35, 40 and 55 Silvercreek Parkway South, Guelph

OPA/ZBLA ZC1510 Draft Plan of Subdivision 23T-19001

Comment Response Matrix for Second Submission

Responses last updated on September 14, 2021

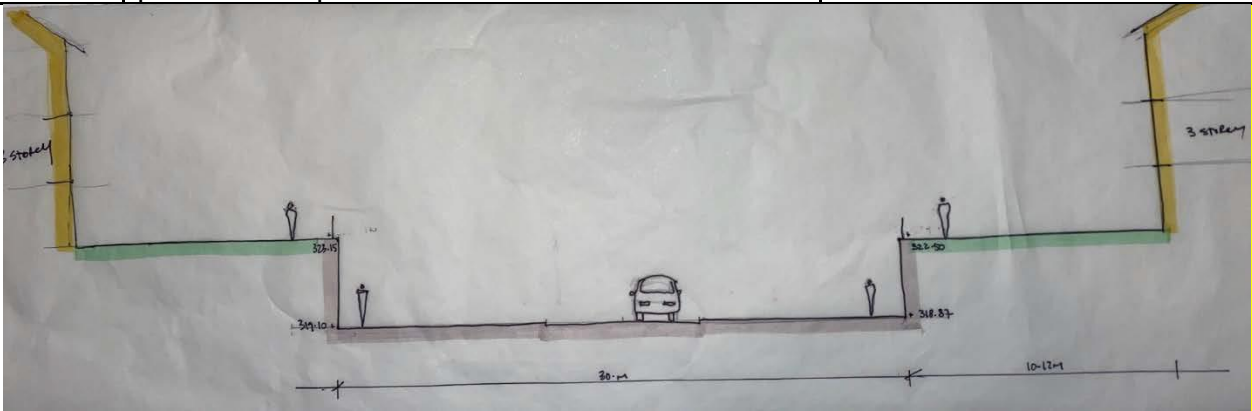
<ul style="list-style-type: none"> Staff is concerned about noise/wall grading around the underpass (Block 5 and 6). A 2m acoustic wall is being proposed in addition (staff note that concept plan in the Noise Study is not consistent with the concept plan submitted). The location of retaining walls associated with underpass should be examined to provide opportunities for street trees, landscaping and best pedestrian experience/comfort. For Discussion. 	
--	---	--
